**RE: National Construction Code (NCC) 2022 Volume One  
Amendment 2 Section J Part J4 Building Fabric Statement of  
Compliance**

**JOB NO.: 250138**

**SUBJECT PREMISE: Retail and Common Areas of 88 Waterloo Rd | 88 Waterloo Rd, Macquarie Park NSW 2113**

DOCUMENT No.: 250138  
 DOCUMENT TITLE: 88 Waterloo Rd - Building Fabric Requirement

1 DA2007 - LOWER GROUND 1:200

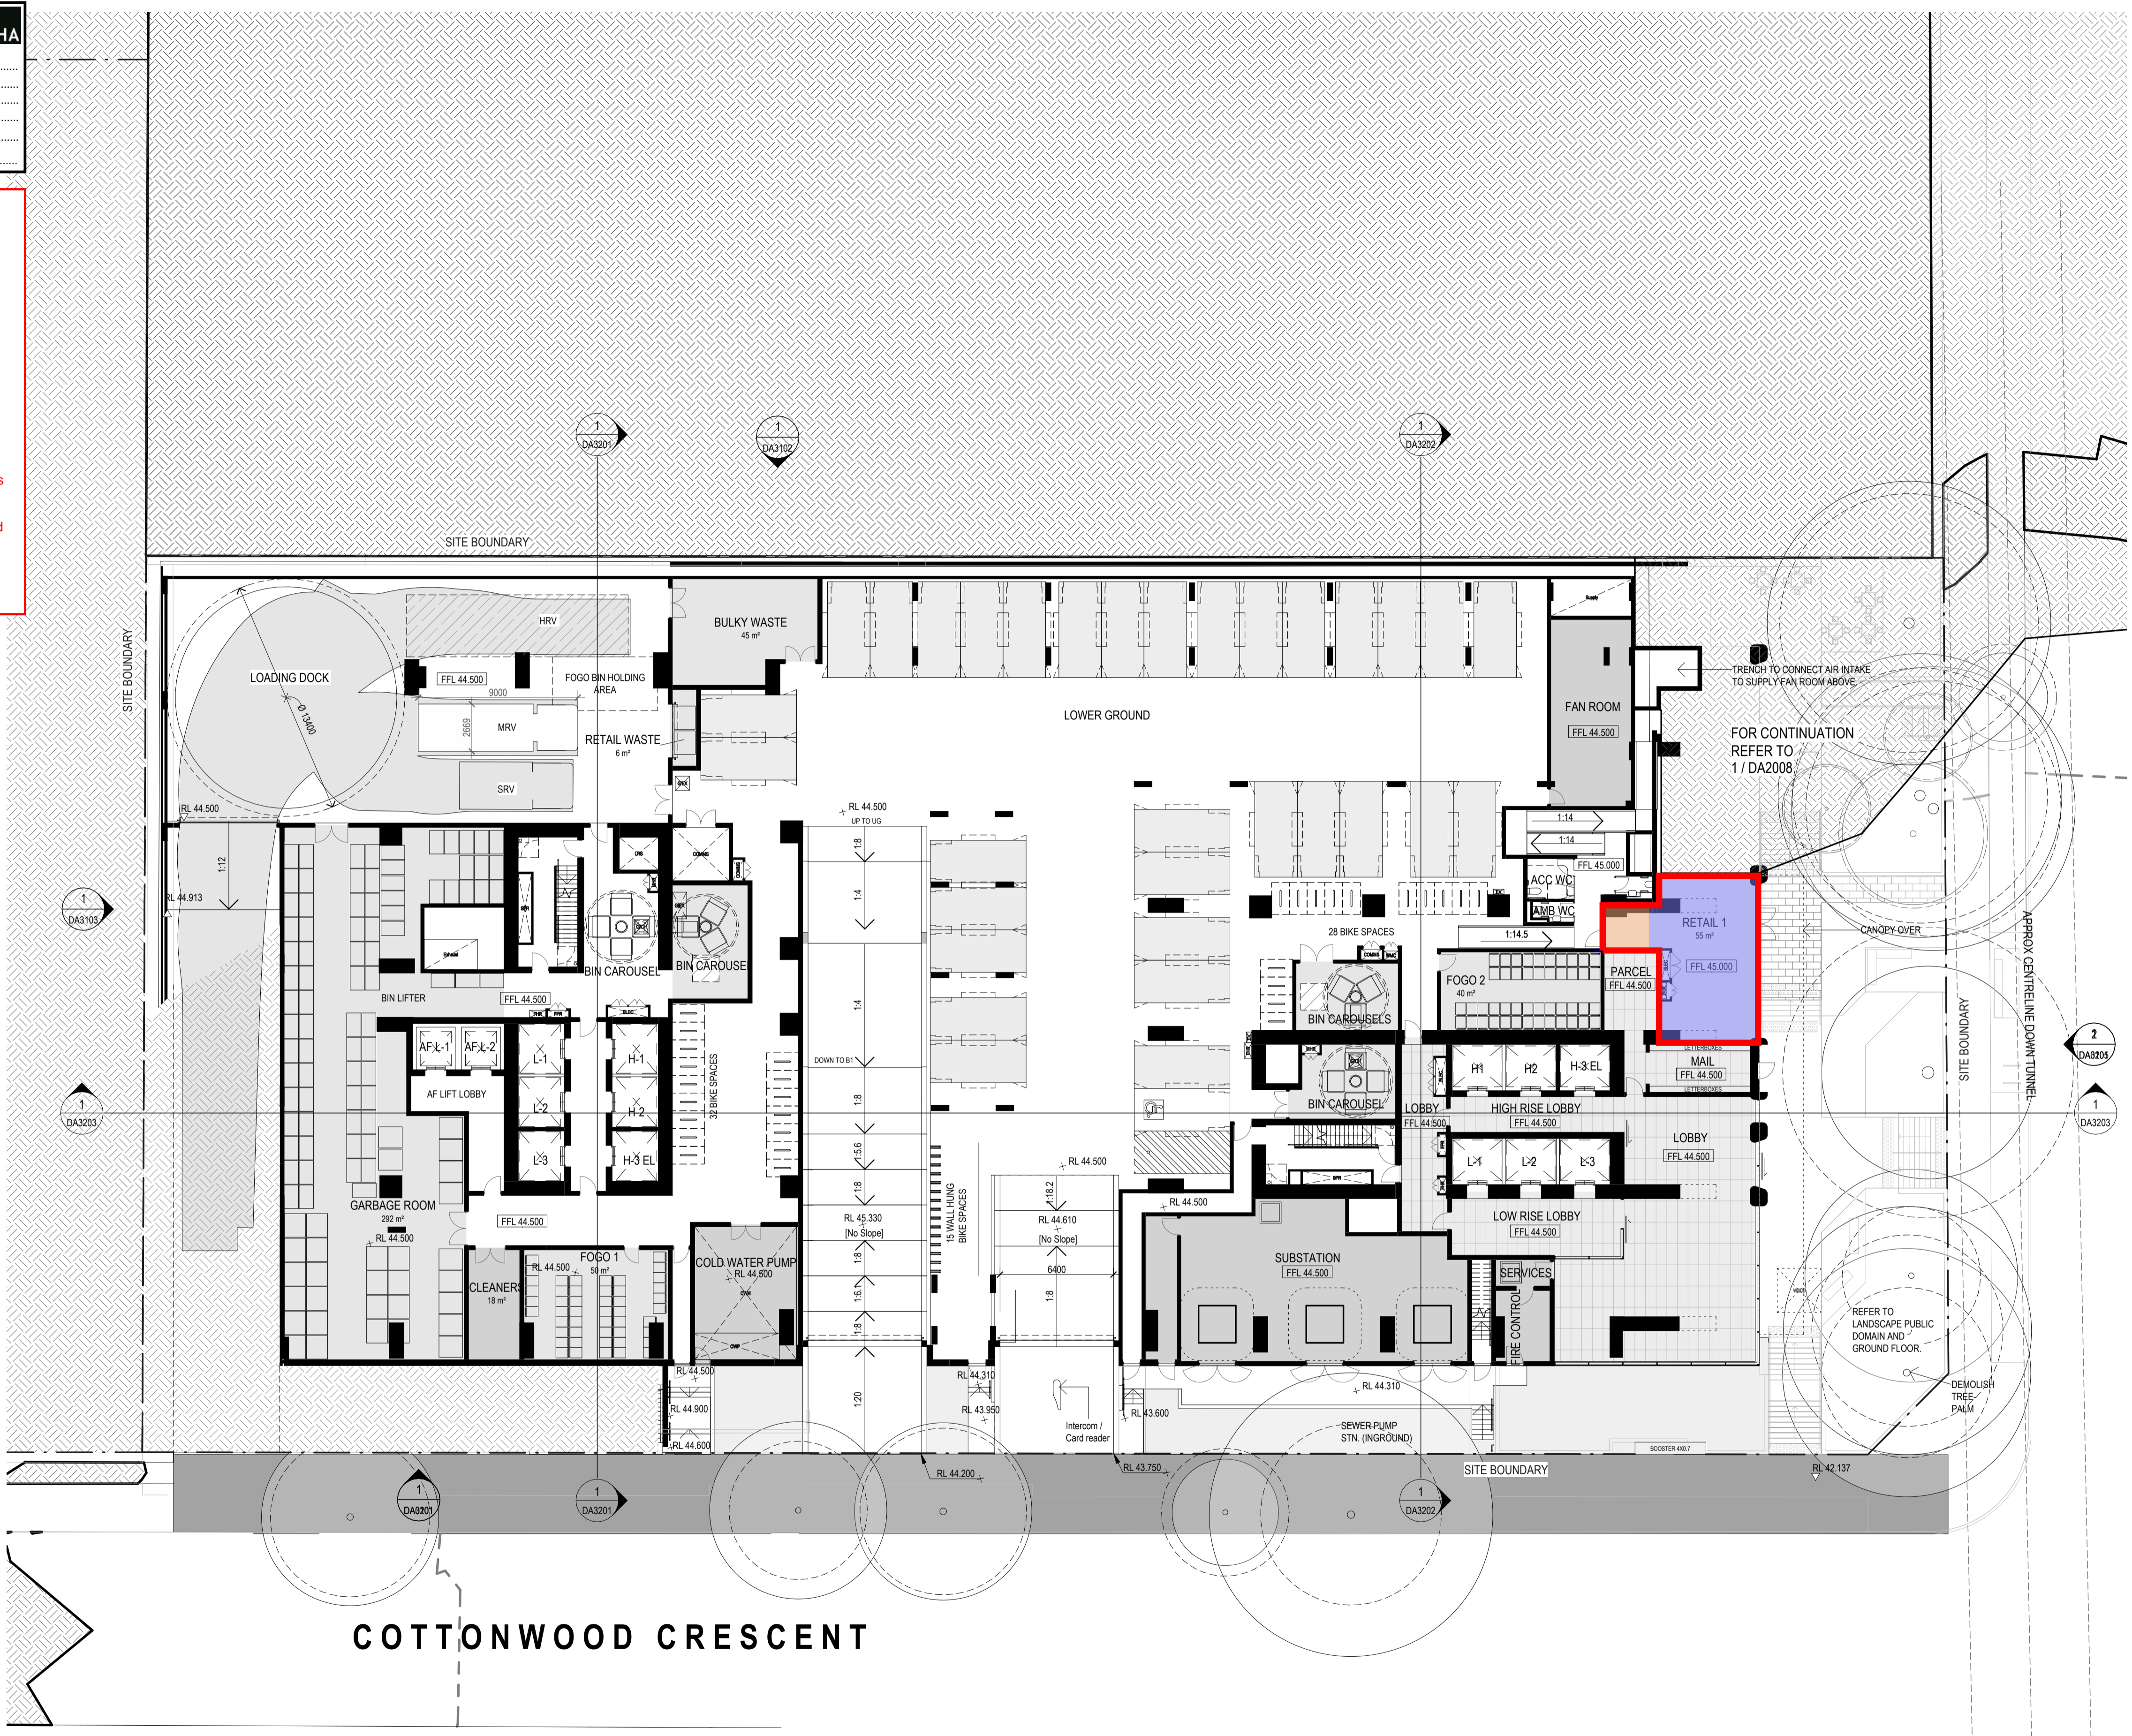
- ROOF/CEILING ENVELOPE: TOTAL R3.7 (DOWNWARD, SOLAR ABSORPTANCE NO MORE THAN 0.45)
- ENVELOPE FLOORS (SUSPENDED): TOTAL R2.0 (DOWNWARD)
- ENVELOPE FLOORS (SLAB-ON-GROUND): TOTAL R2.0 (DOWNWARD)\*
- ENVELOPE WALLS: TOTAL R1.4

Note: The above construction are only to be applied to the non-glazed portions of the envelope; glazing must be installed as per the architectural layouts with its thermal performances pursuant to the Section J report (Total Systems U-Value, and Total Systems SHGC value).

1 DA2008 - UPPER GROUND 1:200

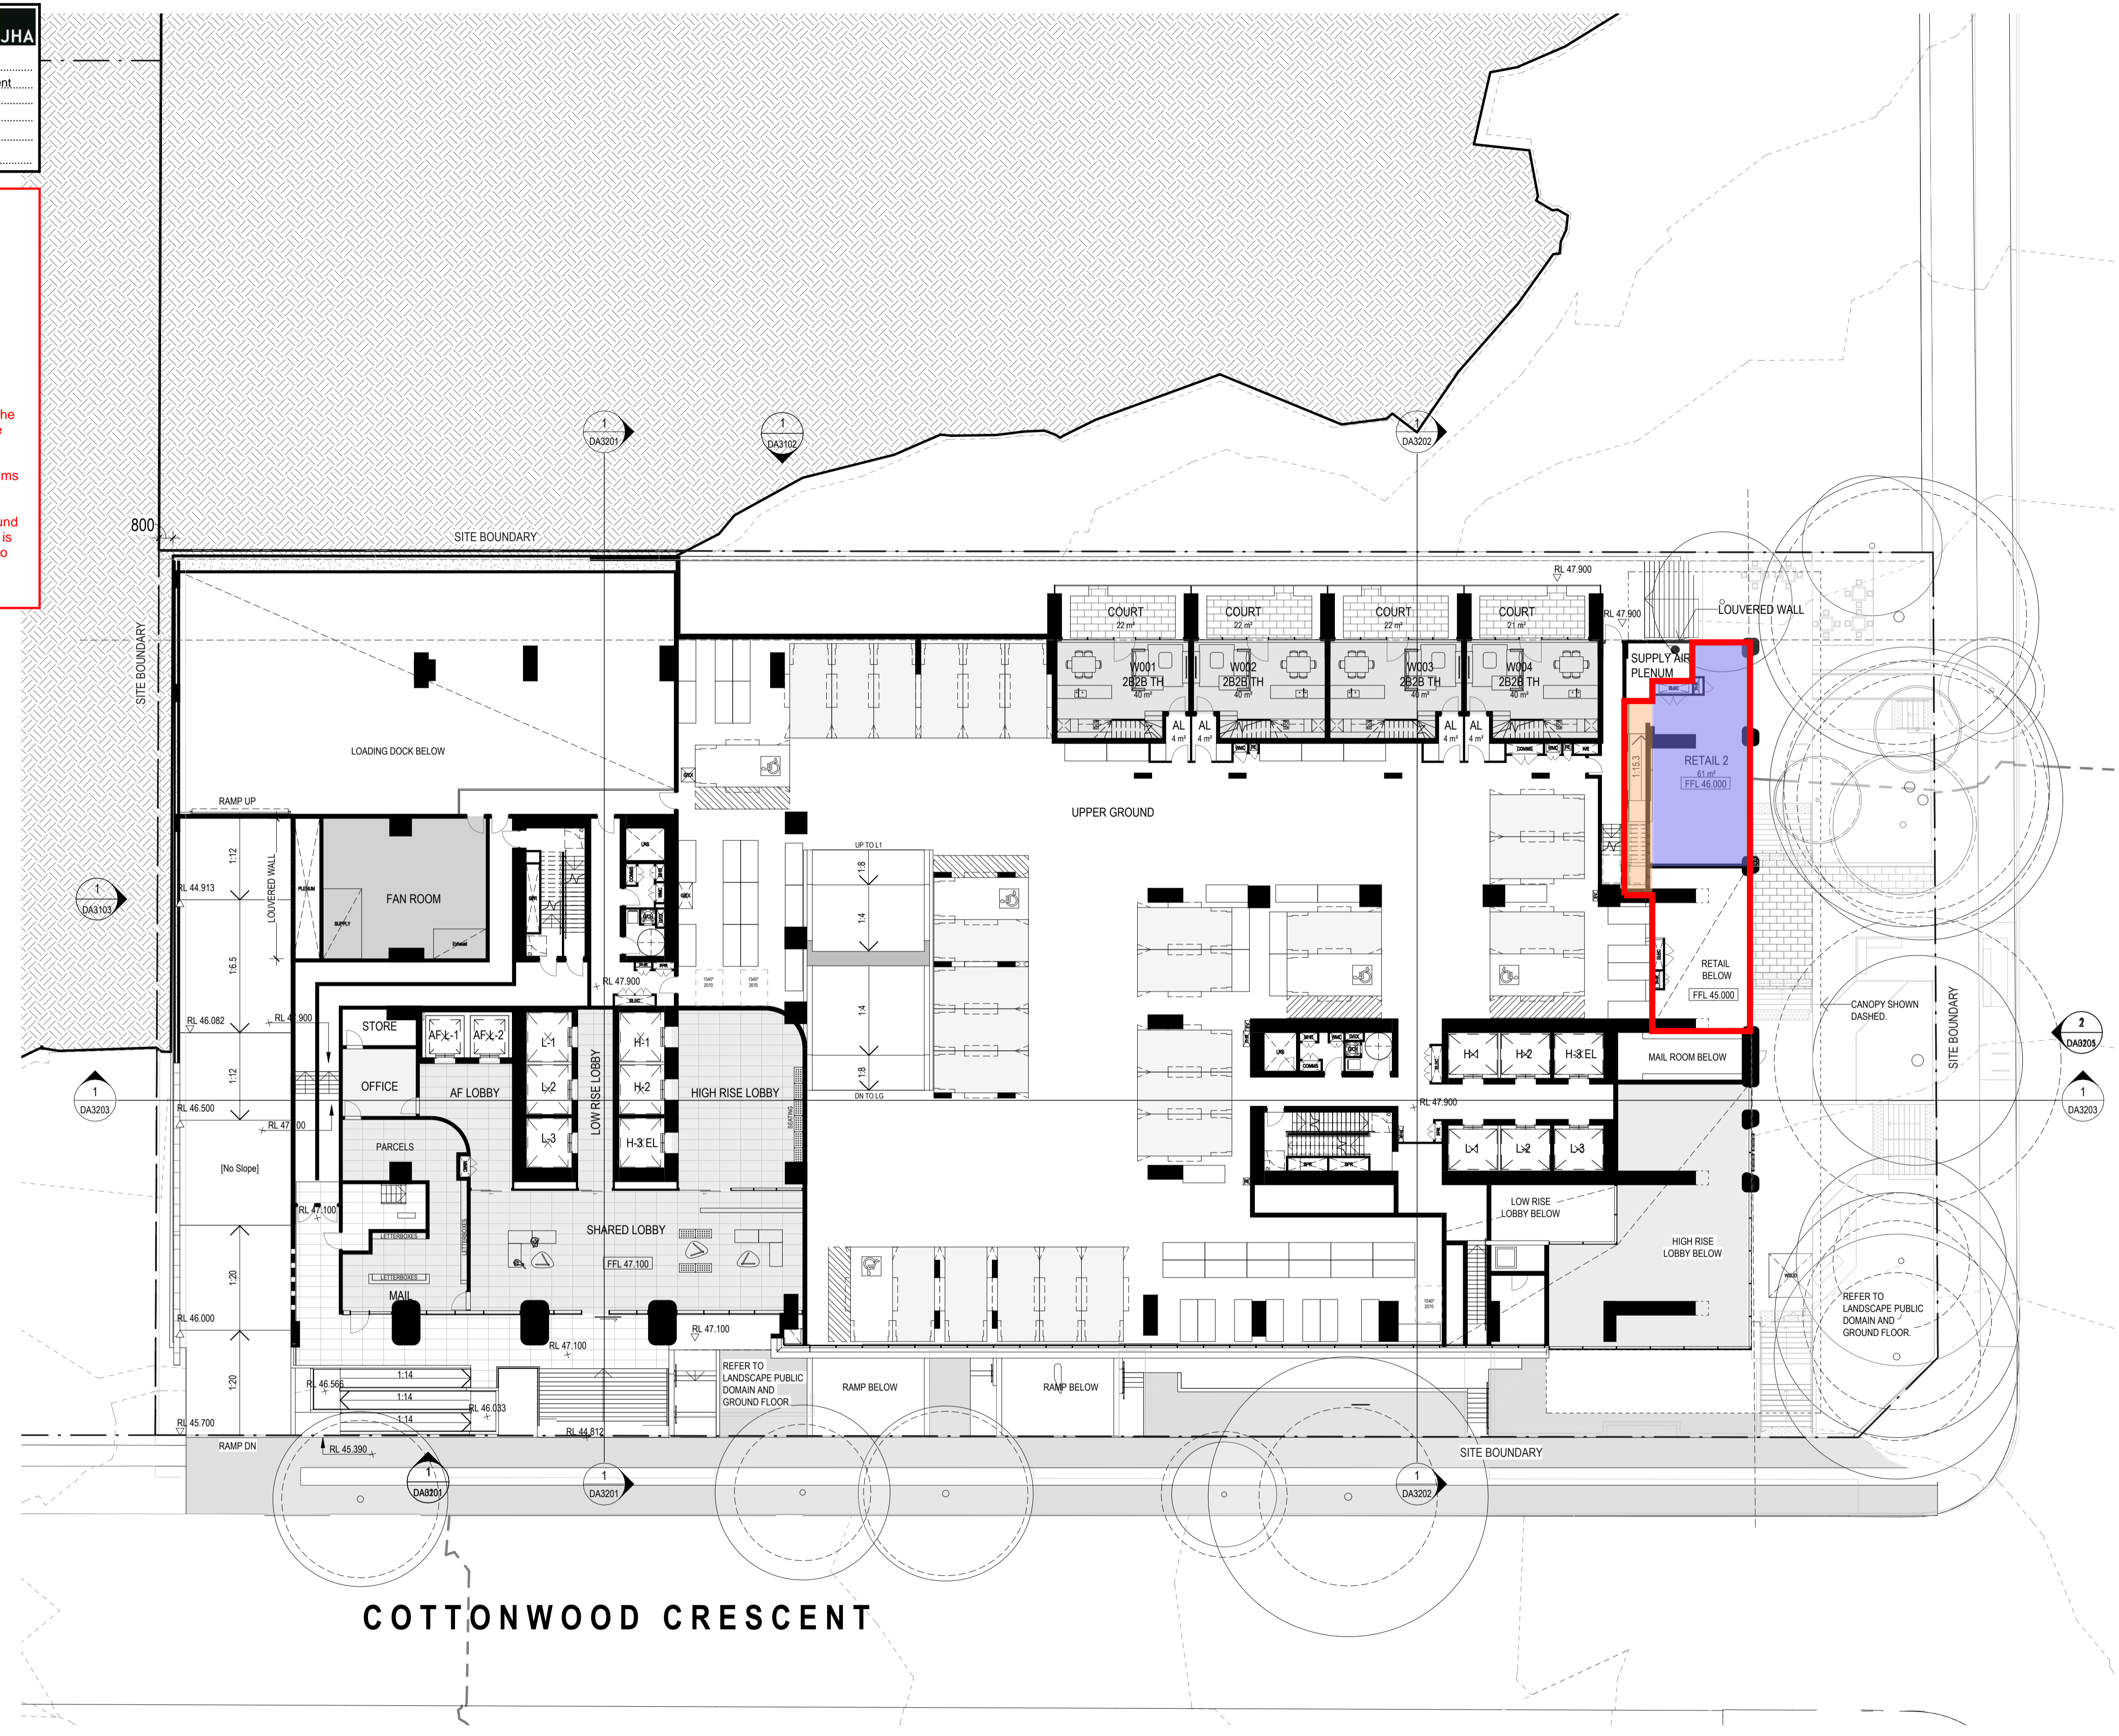
- ROOF/CEILING ENVELOPE: TOTAL R3.7 (DOWNWARD, SOLAR ABSORPTANCE NO MORE THAN 0.45)
- ENVELOPE FLOORS (SUSPENDED): TOTAL R2.0 (DOWNWARD)
- ENVELOPE FLOORS (SLAB-ON-GROUND): TOTAL R2.0 (DOWNWARD)\*
- ENVELOPE WALLS: TOTAL R1.4

Note: The above construction are only to be applied to the non-glazed portions of the envelope; glazing must be installed as per the architectural layouts with its thermal performances pursuant to the Section J report (Total Systems U-Value, and Total Systems SHGC value).
